Wizards Workshop

TEKTRONIX INTERNAL USE ONLY

May 30, 1980
Issue 10-11

401 DRM POWER SUPPLY SQUEGGING

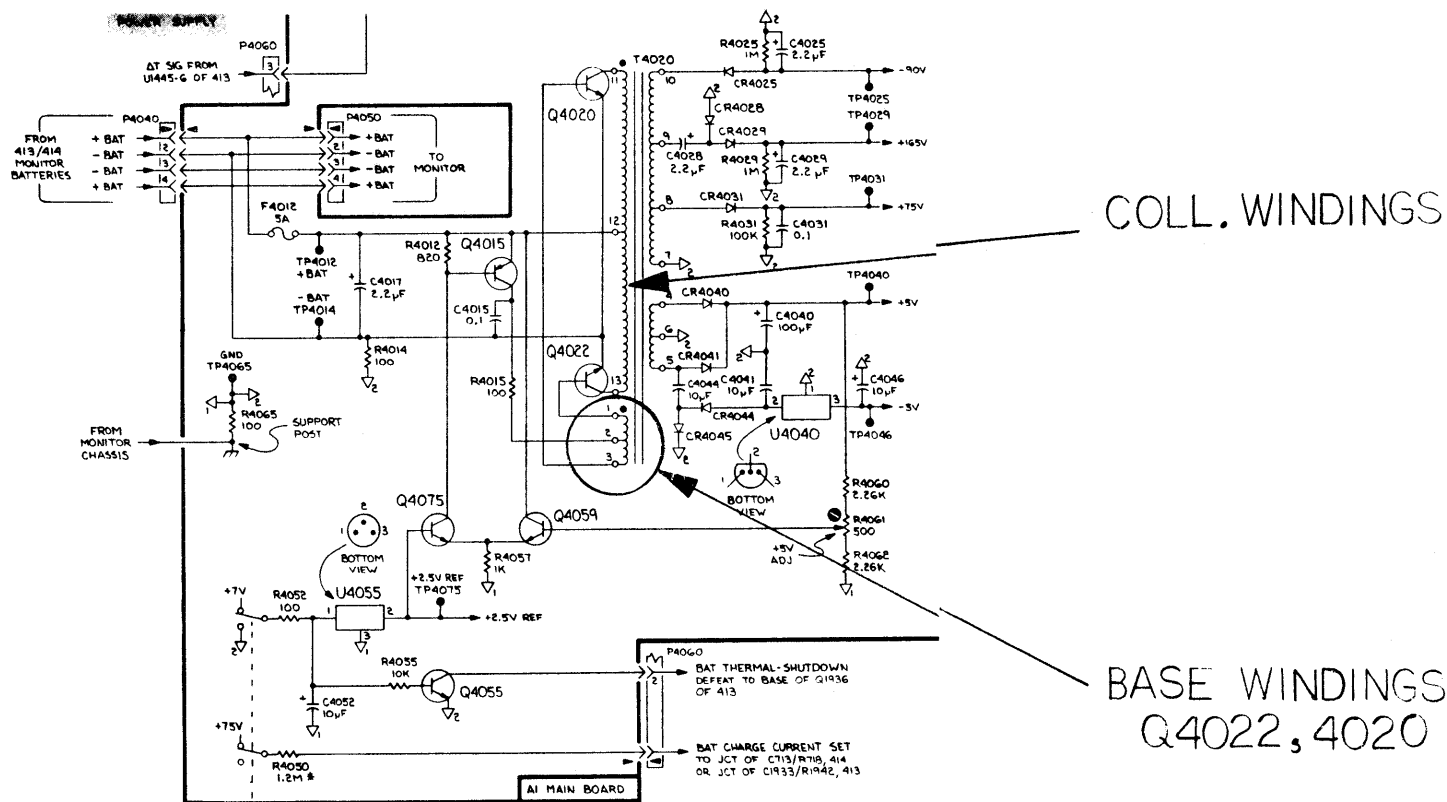
The 401 power supply transformer T4020, with date codes 8014 and below, are mis-wired. THESE SHOULD BE PURGED FROM STOCK. There was a problem in the winding process. The collector and base windings should be wound on top of each other, minimizing capacitance and allowing oscillation at 10KHZ. In the past there was no control mechanism to ensure that the collector and base windings would be wound on top of one another.

Symptoms of the mis-wired transformers are:

- 1) Intermittant on/off
- 2) Slow to turn on
- 3) Oscillating at 100KHZ

Corrective action and controls are in place to prevent the recurrence of this problem.

650A/650HR SERIES, MODIFICATION TO PREVENT SPOT BURNING OF CRT PHOSPHOR

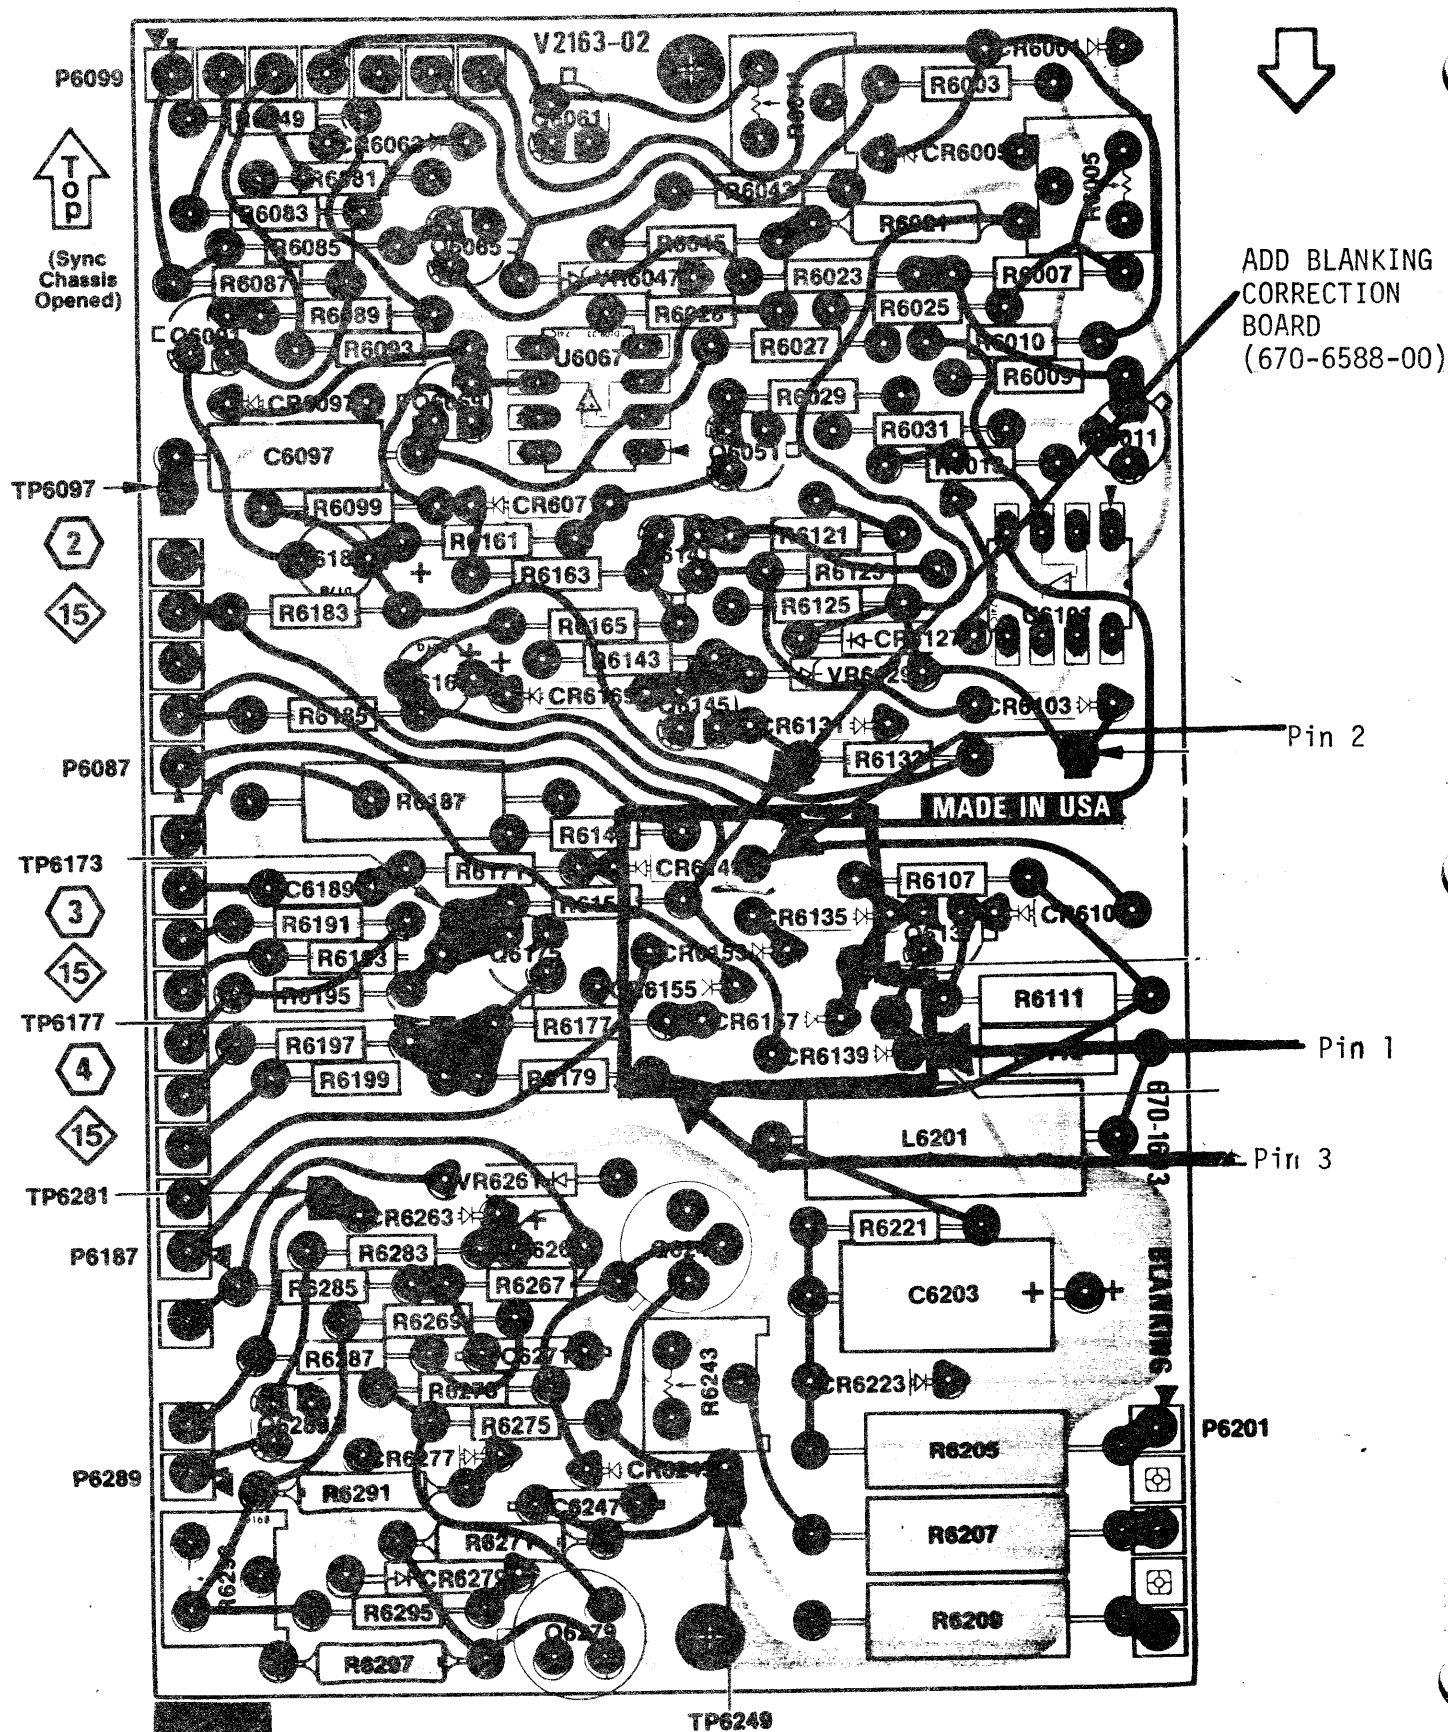
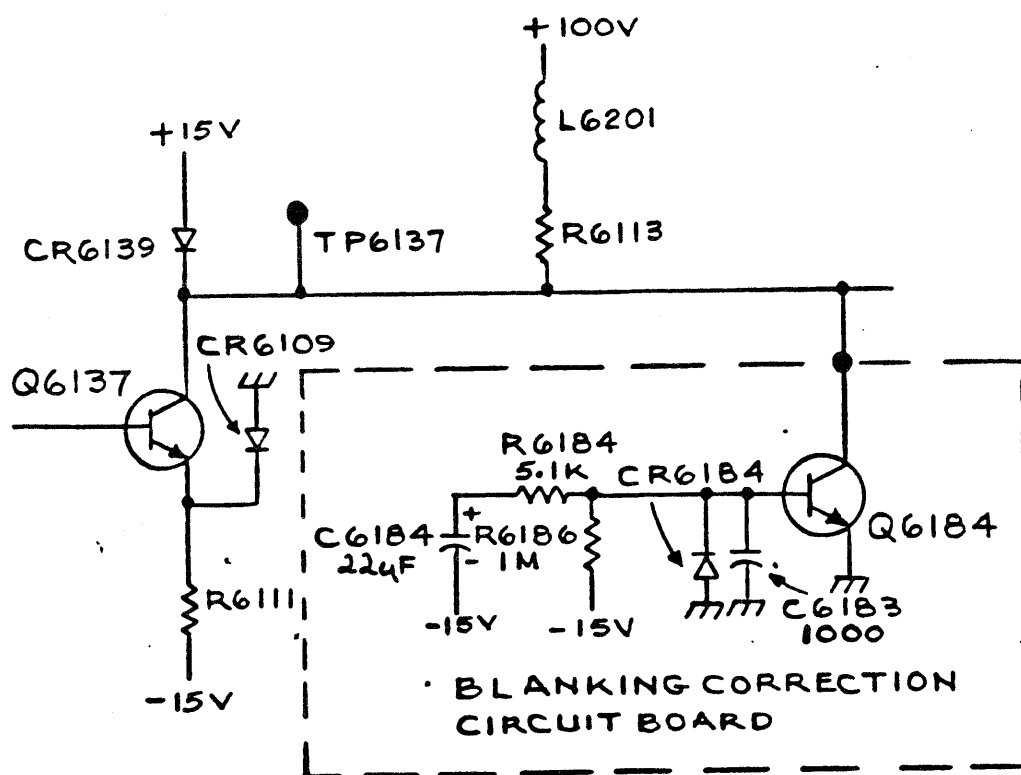
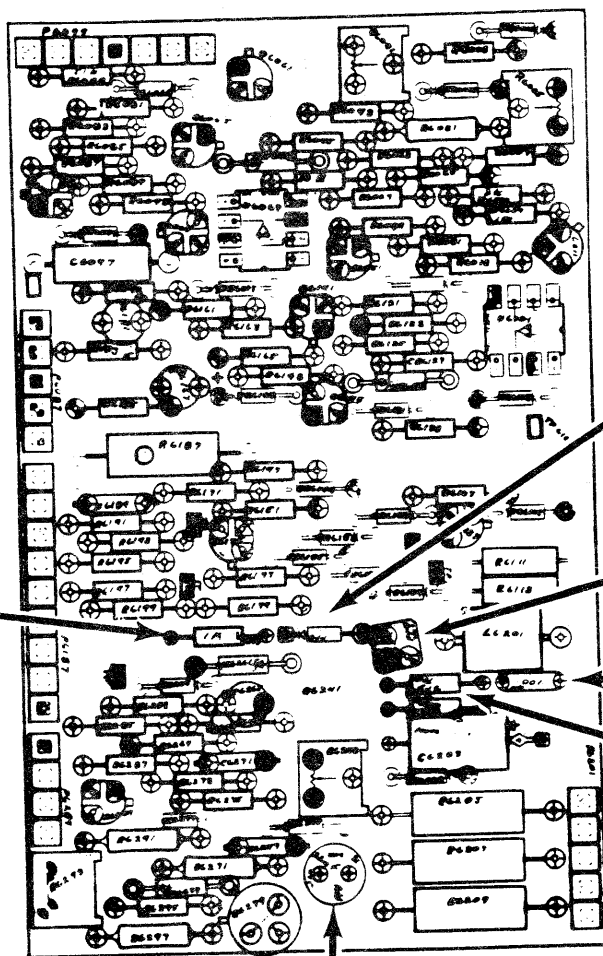
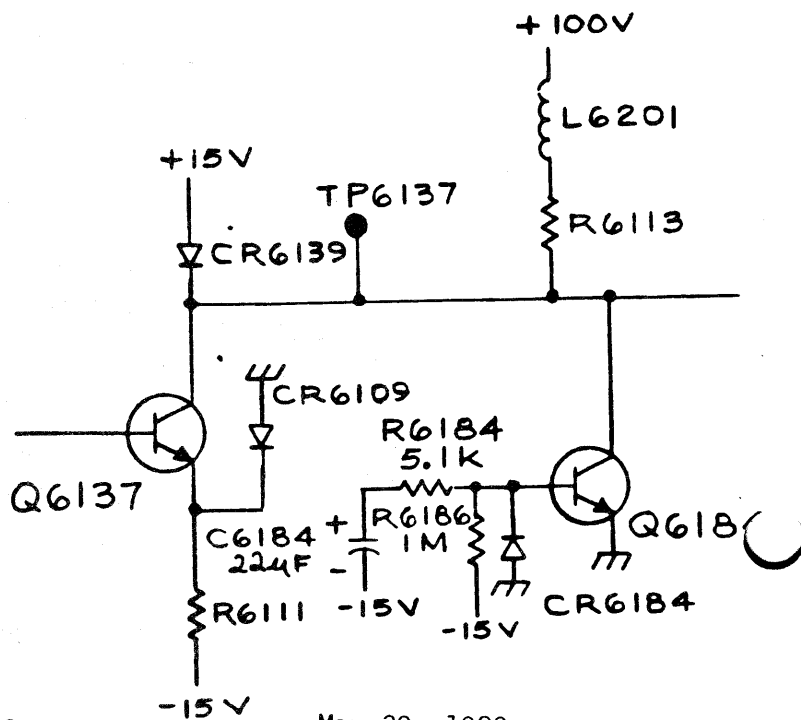
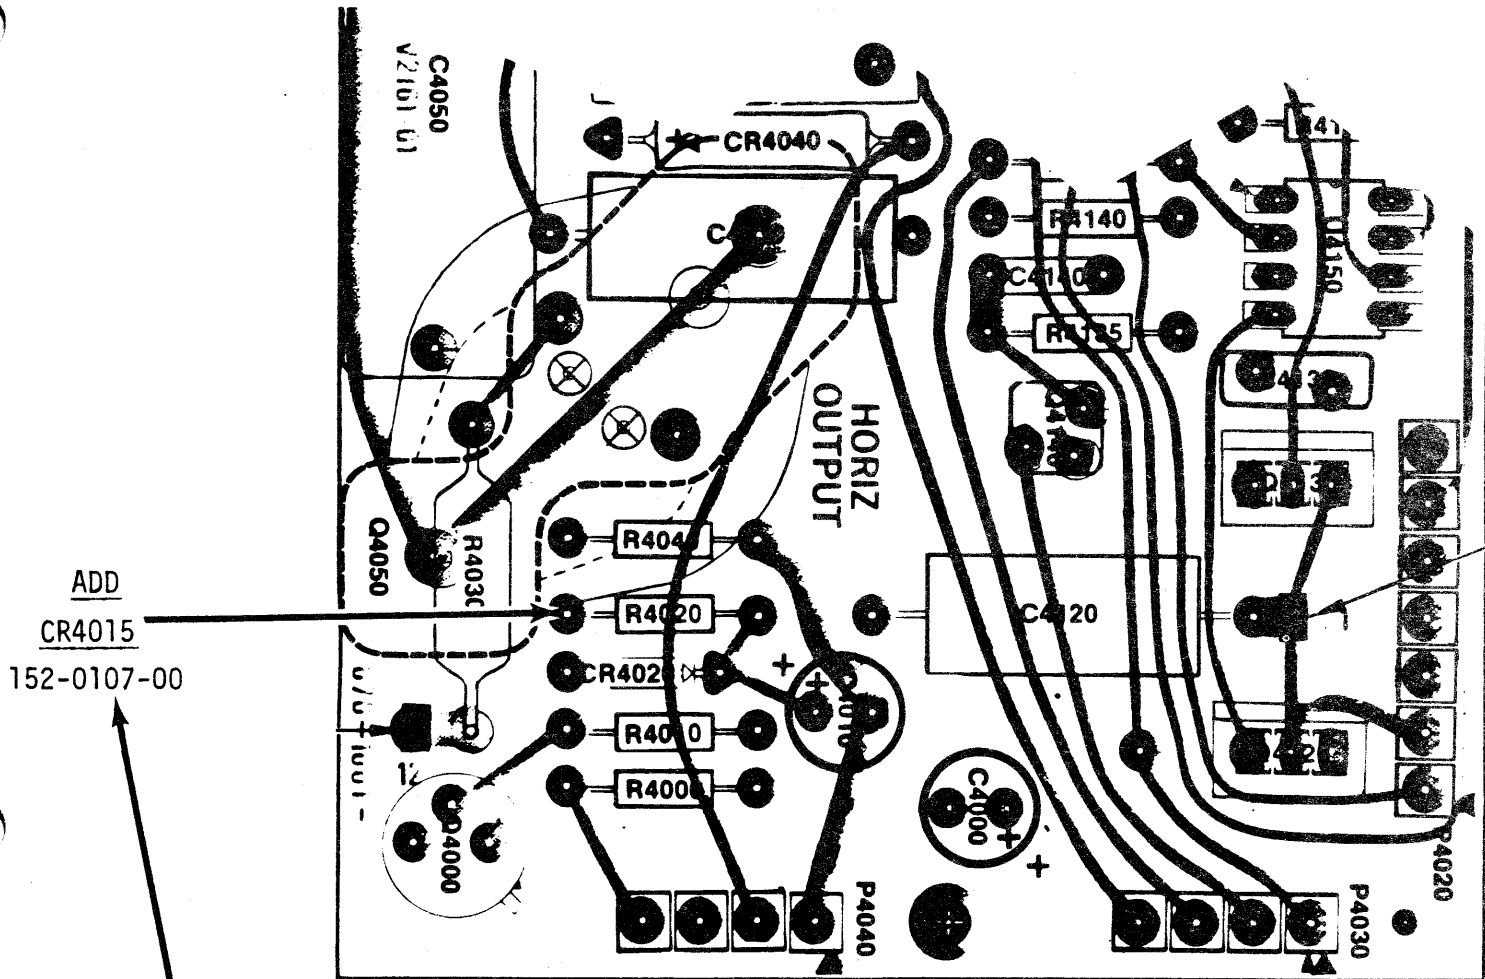
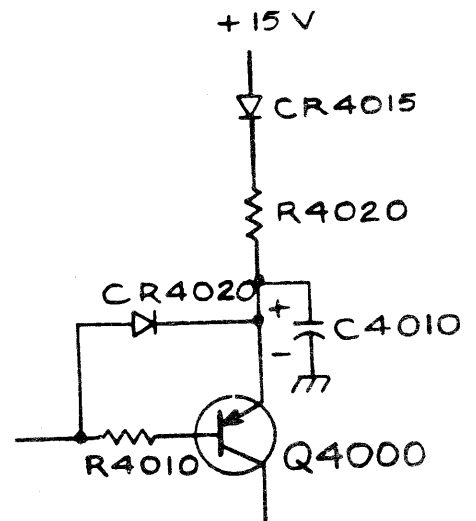
650A/650HR series instruments may exhibit a bright spot in the center screen immediately after shutoff. A modification has been developed to insure that the blanking circuit shuts off the beam before the sweep circuits shutoff. The modification consists of adding a small piggy back circuit board to the blanking board (P/N 670-1603-03). This "Blanking Correction Board" is currently being added to production instruments. The part number of the added blanking Correction Board is 670-6588-00. The board is attached by soldering the three square pins on the bottom of the Blanking Correction Board to the following locations:

- Pin 1 - Junction of CR6139 cathode and R6113 (10K ohm)
- Pin 2 - Junction of CR6149 anode and CR6109 anode
- Pin 3 - Junction of R6179 (6.2Kohm) and R6111 (1K ohm)

Also CR4015, P/N 152-0107-00 diode is added to the horizontal output board. Lift the end of R4020 closest to R4030. Solder CR4015 anode to the board and teepee the cathode end to the lifted end of R4020.

See the following drawings for the layout of parts and updated schematics. The Blanking Board, P/N 670-1603-03 will change suffix numbers when the Blanking Correction Board parts are incorporated into the Blanking Board. A schematic and new board layout is included with this article.

CR4015 AND R4020
ARE TEEPEED OVER
CIRCUIT BOARD

DIAGRAM 12 HORIZONTAL DEFLECTION (670A & 671A) DIAGRAM 5_b 670A-1 SERIES

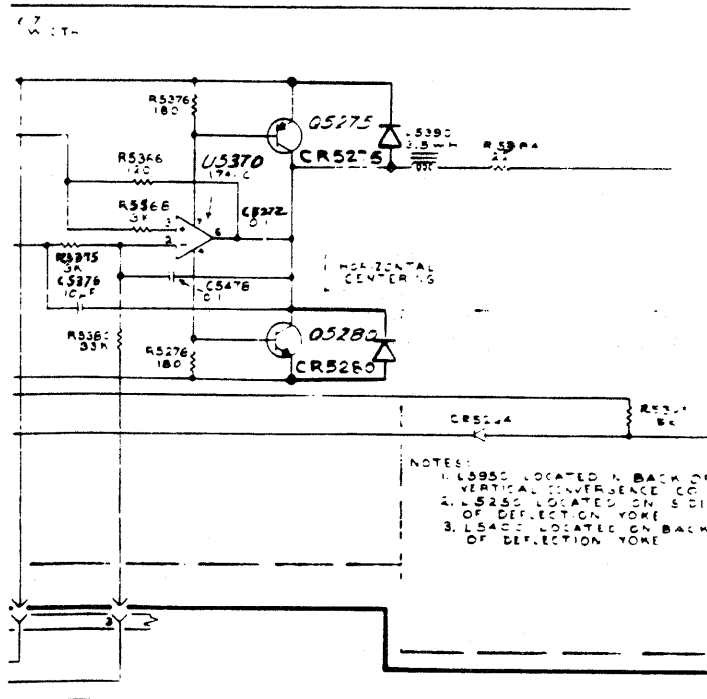
To correct these malfunctions, change R5085 from 56 ohms to 27 ohms (303-0270-00) and change L5085 from 10 microhenries to 5 microhenries (108-0554-00). Add diodes CR5275 and CR5280 (both 152-0398-00) across Q5275 and Q5280, respectively. Connect the cathode of CR5275 to emitter of Q5275 and connect anode of CR5275 to collector of Q5275. Connect cathode of CR5280 to collector of Q5280 and connect anode of CR5280 to emitter of Q5280. (See the following schematic for changes.) A parts kit is available for both modifications.

ADD:

CR5275 152-0398-00 SEMICOND DEVICE:SILICON,200V,1A,1N4935

CR5280 152-0398-00 SEMICOND DEVICE:SILICON,200V,1A,1N4935

670A/671A, UNWANTED VERTICAL LINE IN YELLOW COLOR BAR

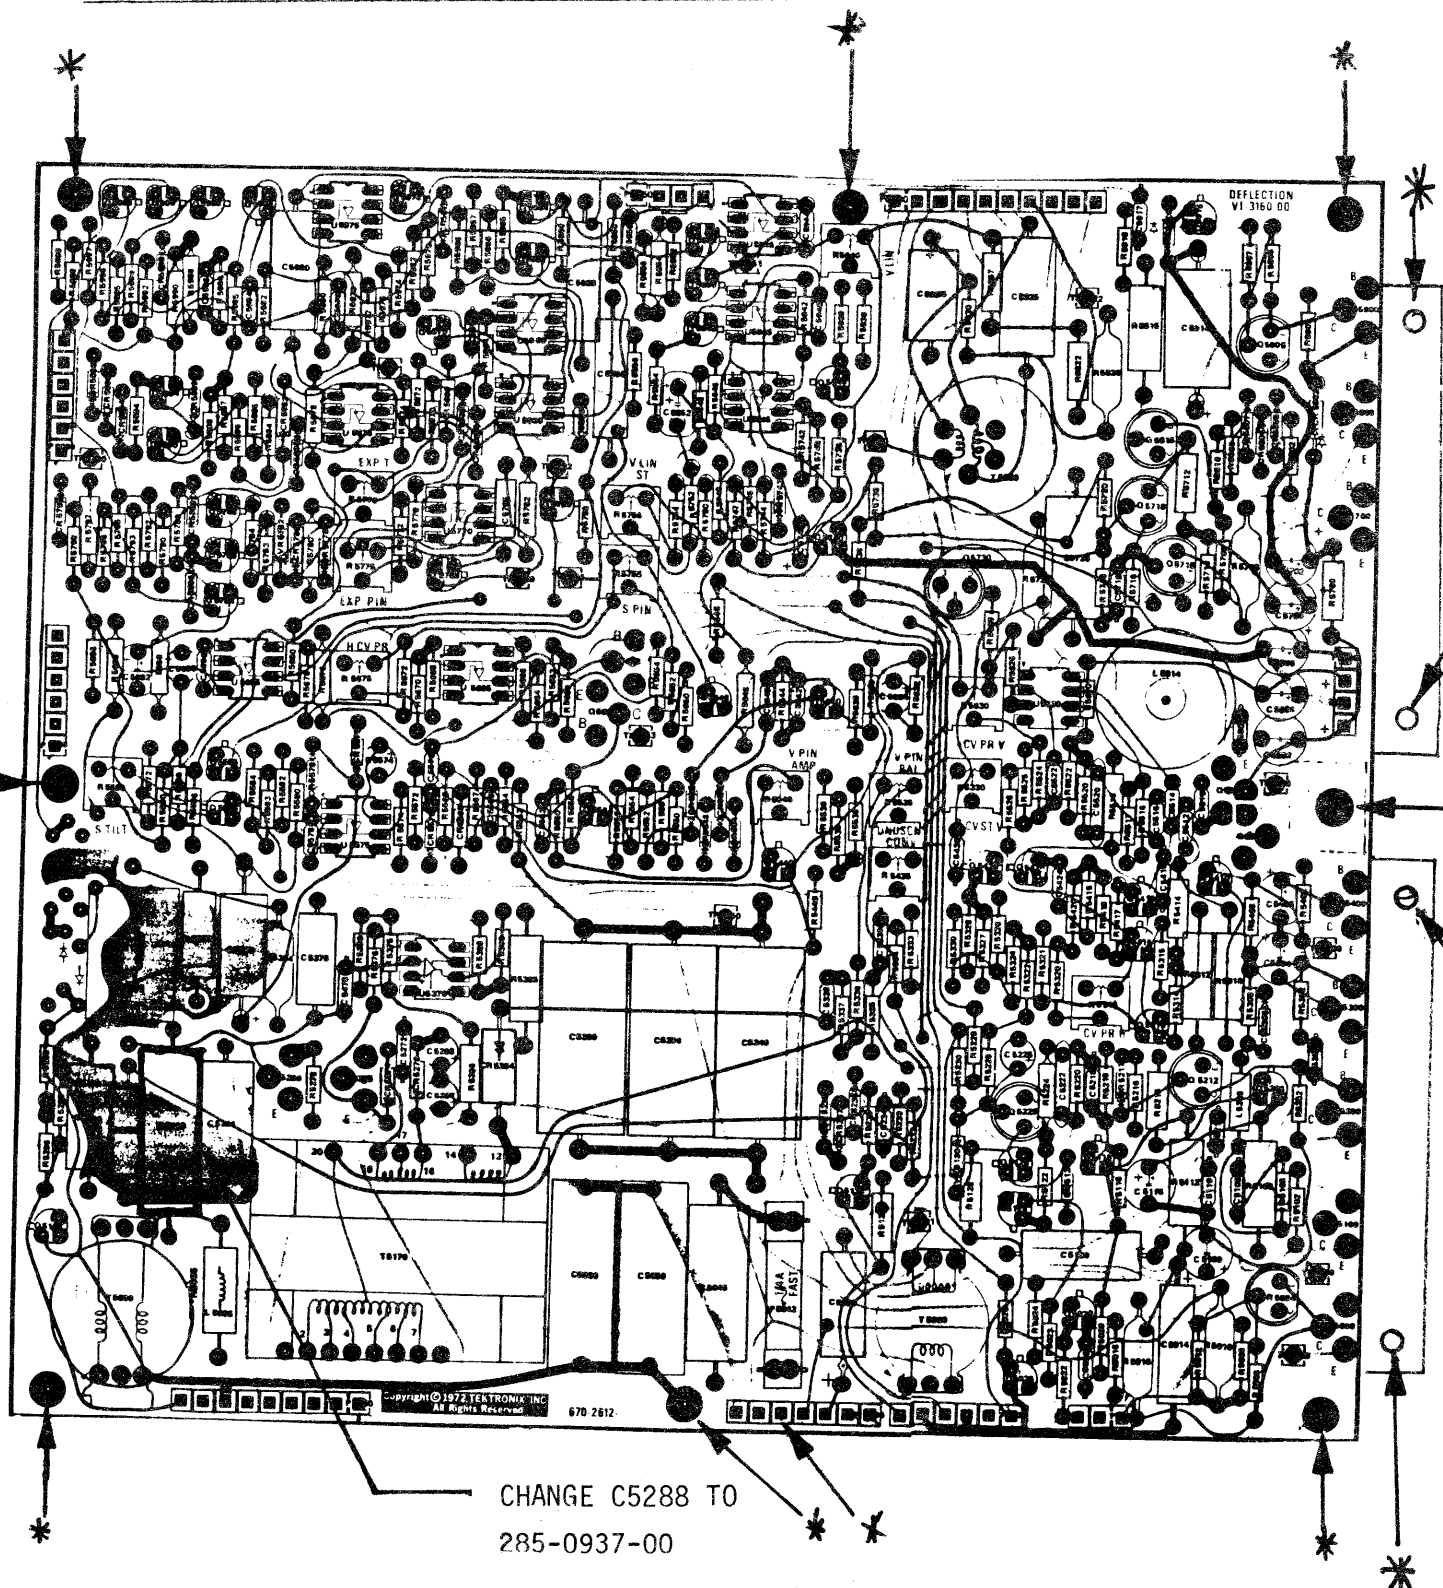
Some 670A/671A color monitors may exhibit a very faint light vertical line approximately 2.5 inches (6.35cm) from the left edge of the screen (in the yellow bar). The line is caused by a high ground current spike generated when Q5001 turns off. This line may become slightly more visible with the addition of the modification to the horizontal output circuits (see article in this issue).

The line can be made less visible by replacing C5288, P/N 285-0515-00, 0.022 microfarad capacitor with P/N 285-0937-00, 0.068 microfarad capacitor and also by reducing resistance to ground from the deflection board by tightening the grounding screws and inspecting the other grounding connections on the deflection board. The locations of possible grounding problems and the location of C5288 are shown on the following drawing.

* CHECK GROUND CONNECTION
